Ventura County Community College District

DATE: May 15, 2025
TO: All Bidders
FROM: Spencer Herson, Purchasing Specialist
SUBJECT: Addendum 1 – Bid 709, Ventura College Stem Program Building Improvements

Drawings: Changes and clarifications noted as Addendum 01 and dated 05/15/25

CONCRETE V-GUTTER

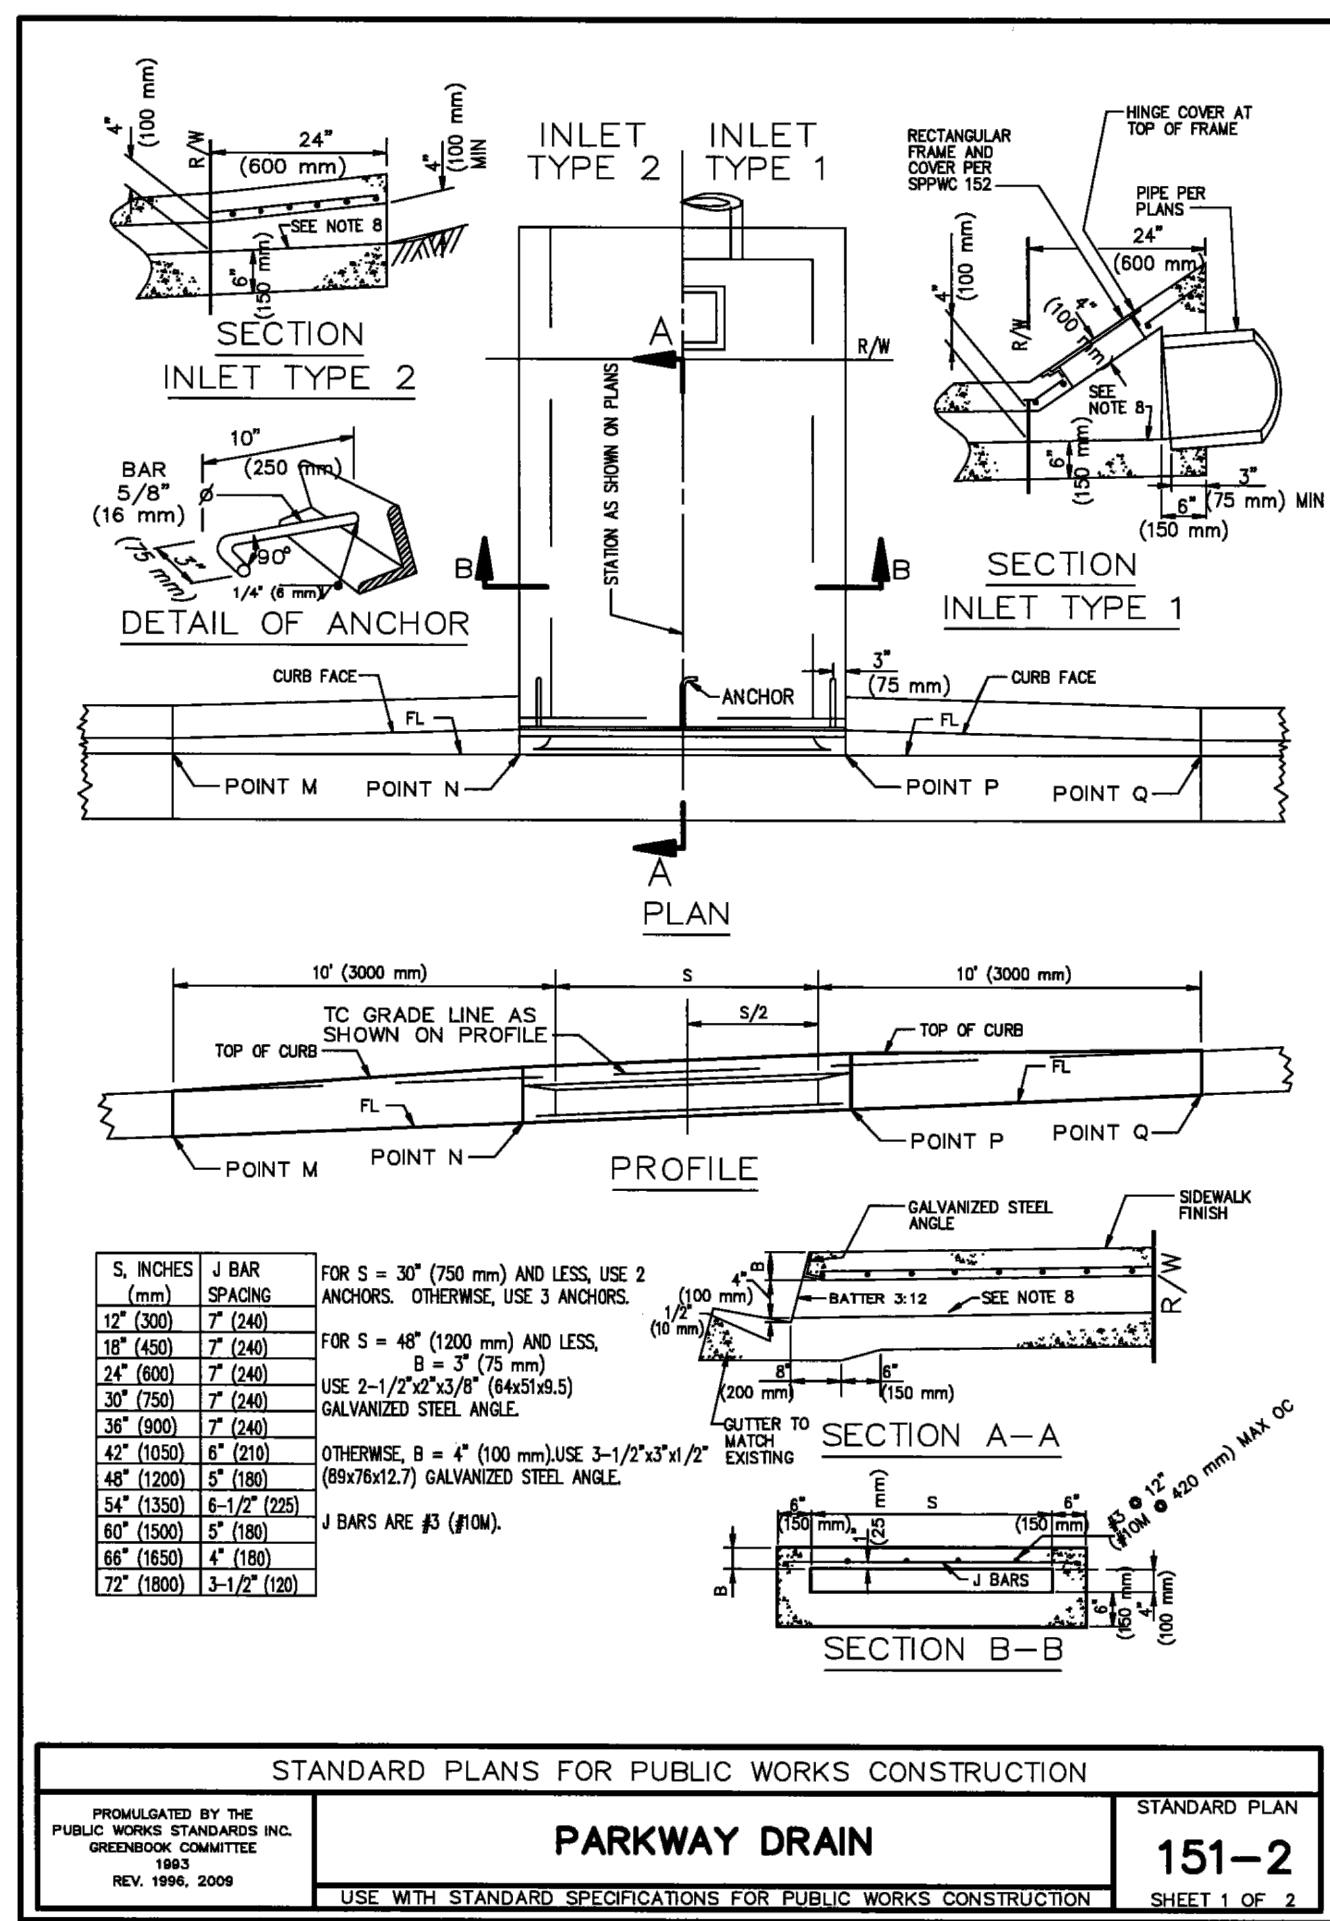
C5.1 – ADDED REINFORCEMENT TO TRENCH DRAIN DETAIL 12/C5.1, NEW CONCRETE V-GUTTER DETAIL 18/C5.1

C6.1
DATE: SHEET 5 OF

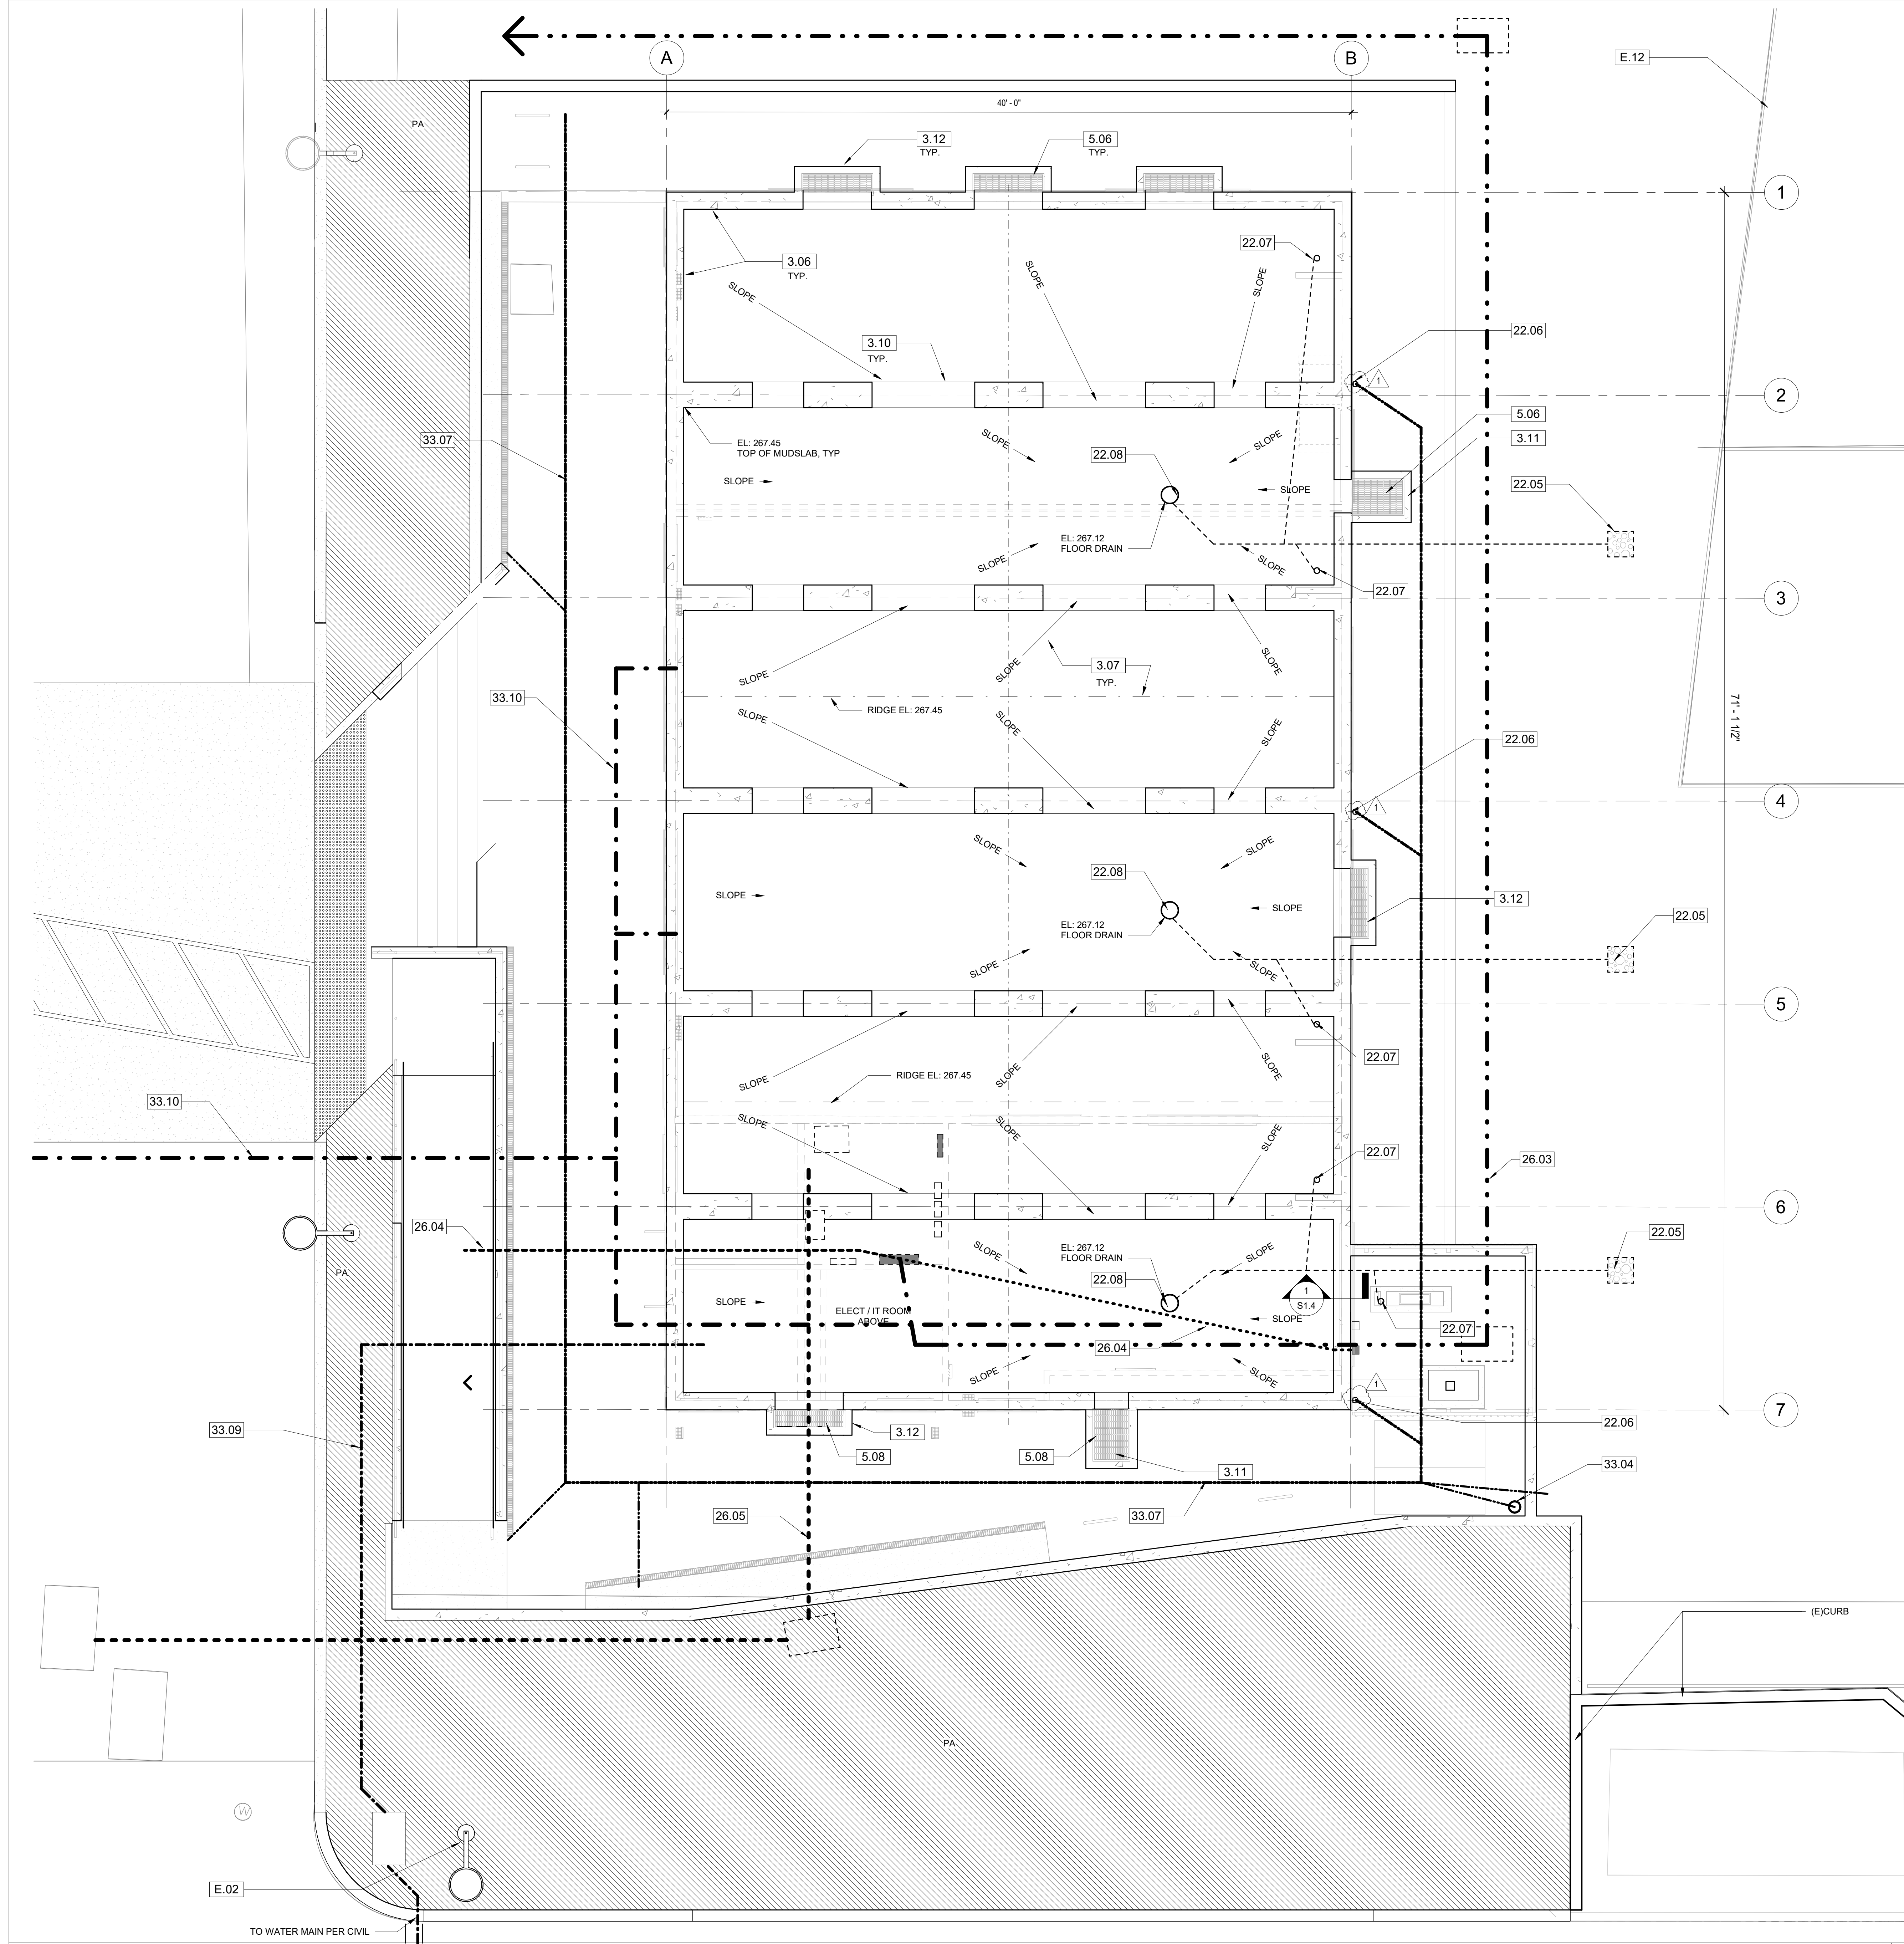
C6.1 – EROSION CONTROL PLAN FOR DROP-OFF AREA

A103

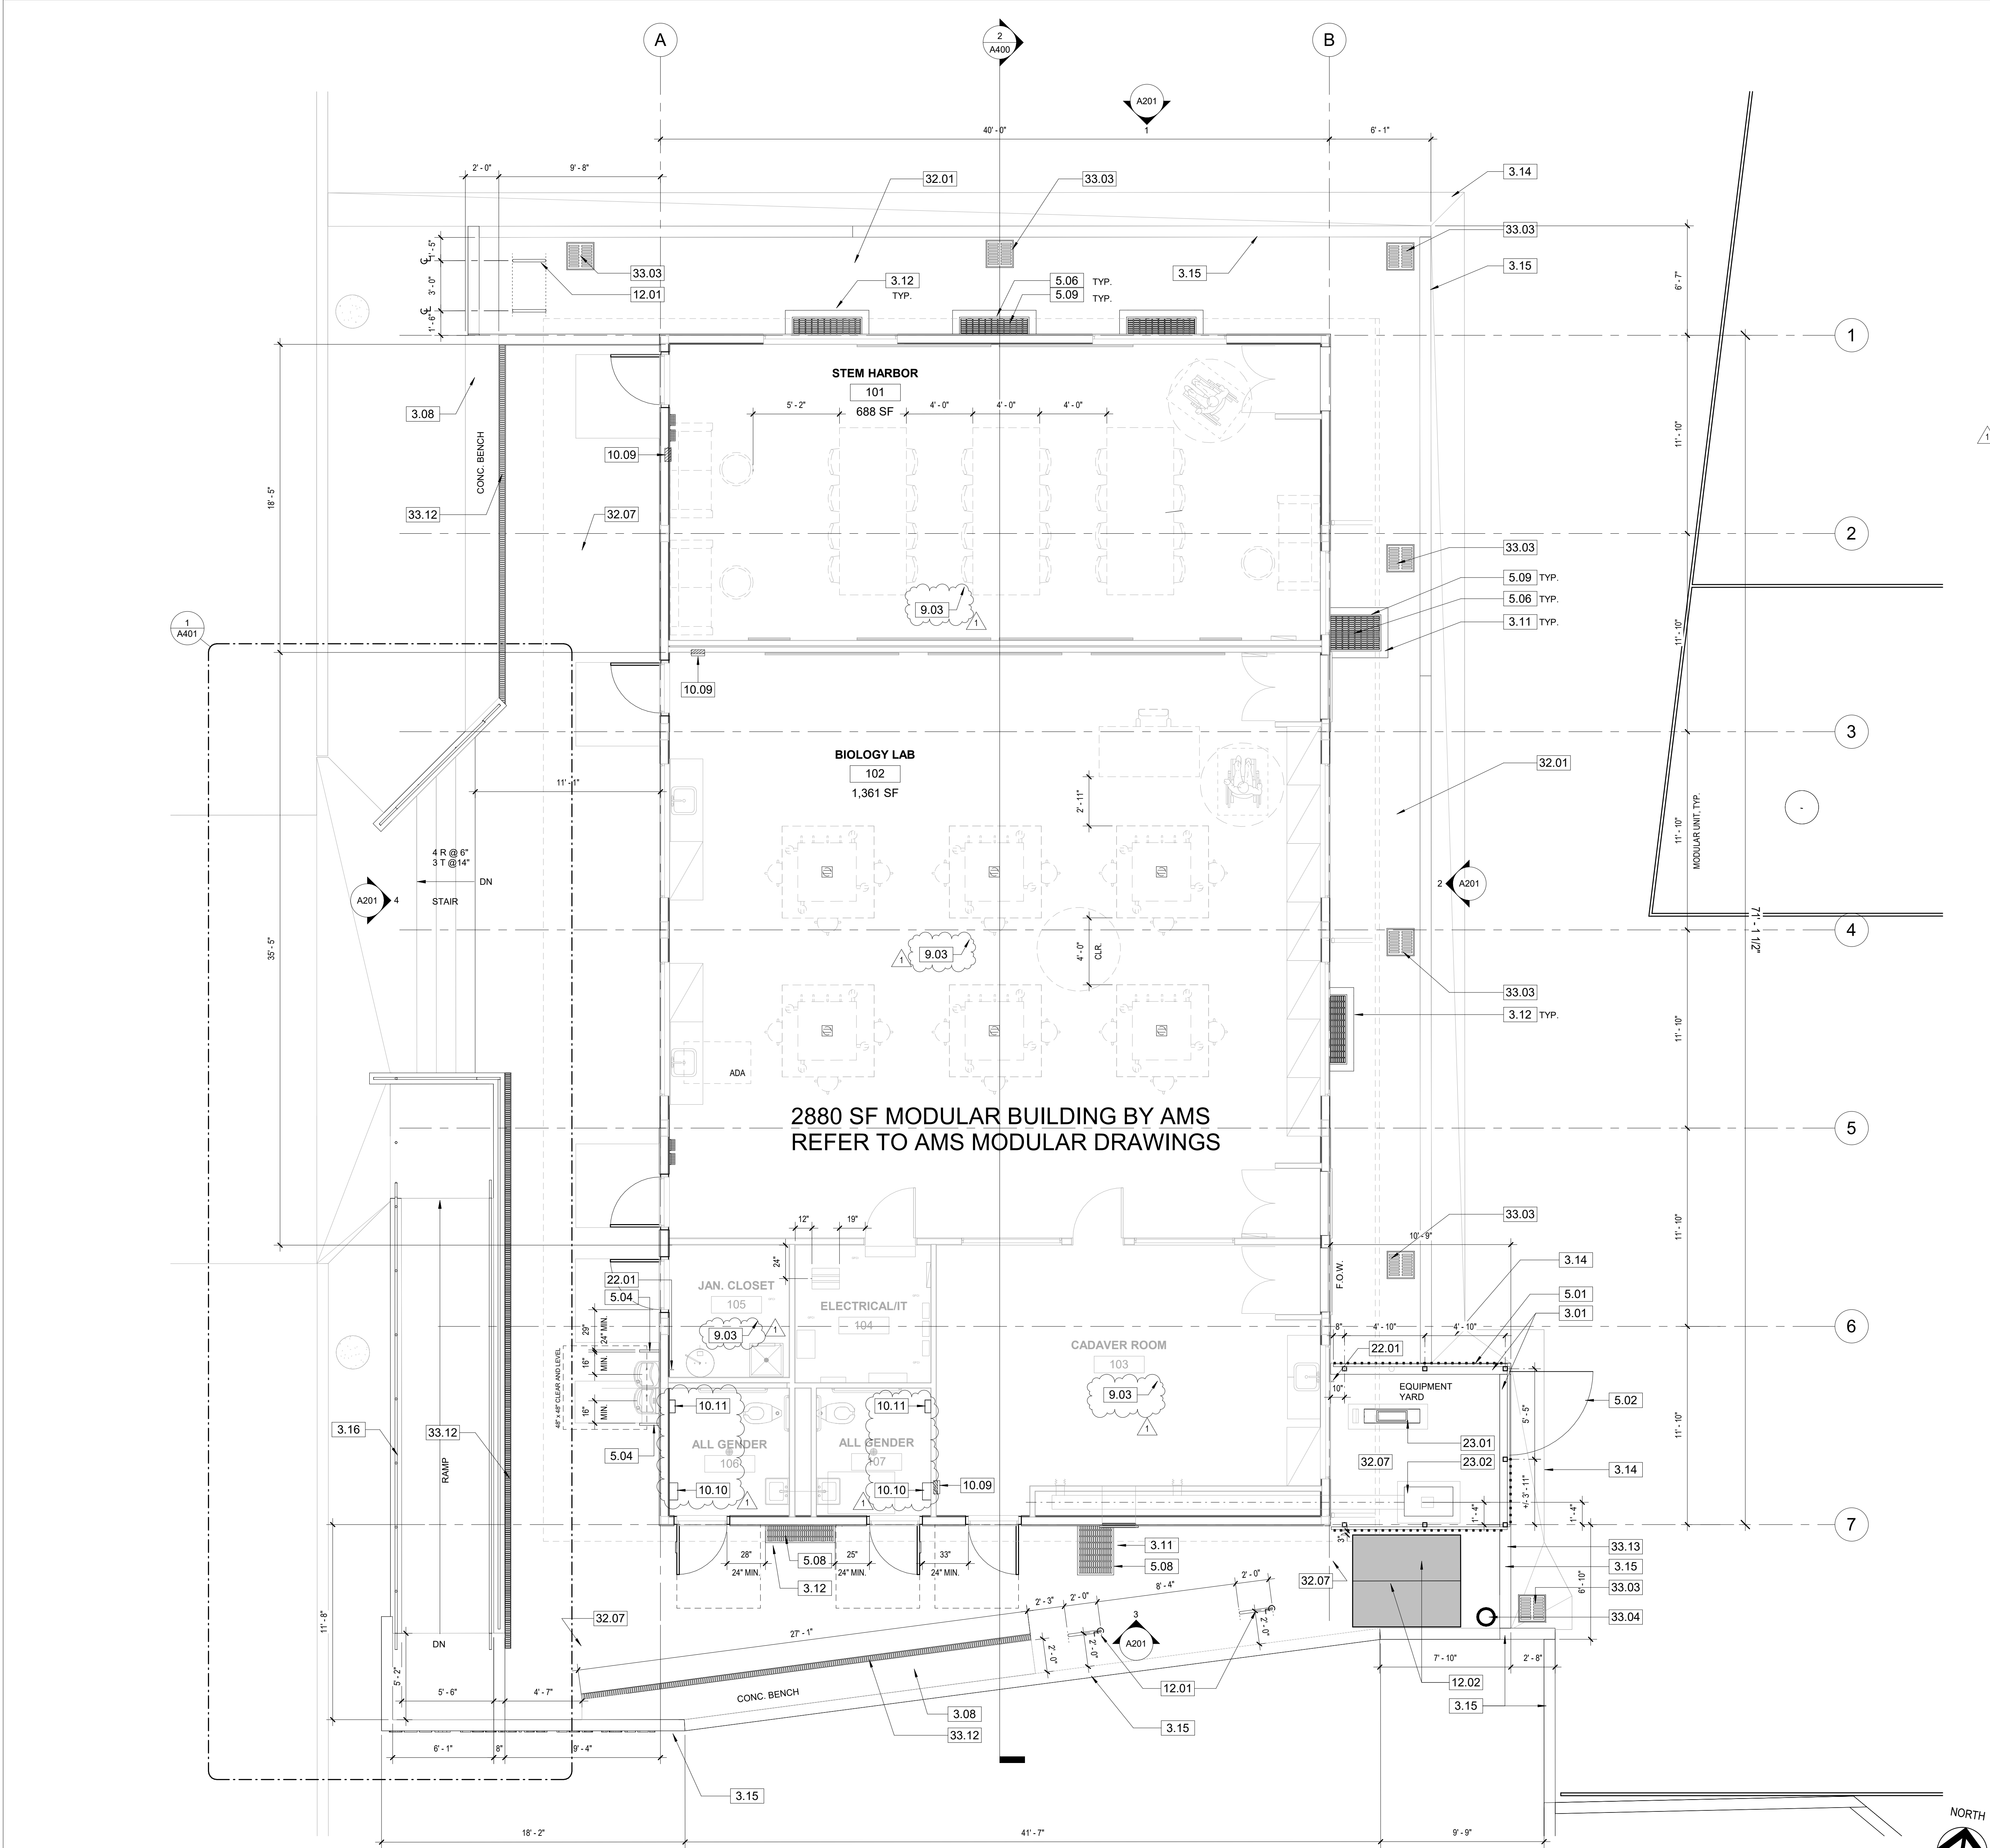
A103 –DETAIL 2/A103 CONNECTION TO STORM DRAIN ADDED, REFERENCED IN KEYNOTE 22.06
